S E R V I C E N O T E

6010A Autoranging DC Power Supply

Serial Numbers: 3105A00980 / 3140A01119

Modification using RTV to prevent W8 Ribbon Cable disconnect.**Duplicate Service Notes:**

Figure 1

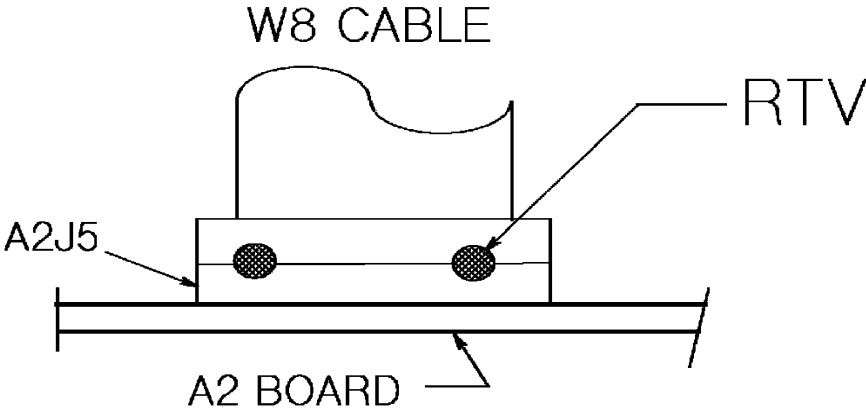
The W8 ribbon cable connecting the A1 main board assembly to the A2 Control board assembly may vibrate loose during transportation. This only involves units with serial numbers inclusive of those listed above.

Reconnect the W8 ribbon cable. Use RTV to secure the W8 connector to the J5 mating connector on the A2 assembly. Put a 8 mm (0.313 in) size spot bridging the W8 / J5 connectors. Bridge the connectors with an RTV spot at each end as shown in figure 1.
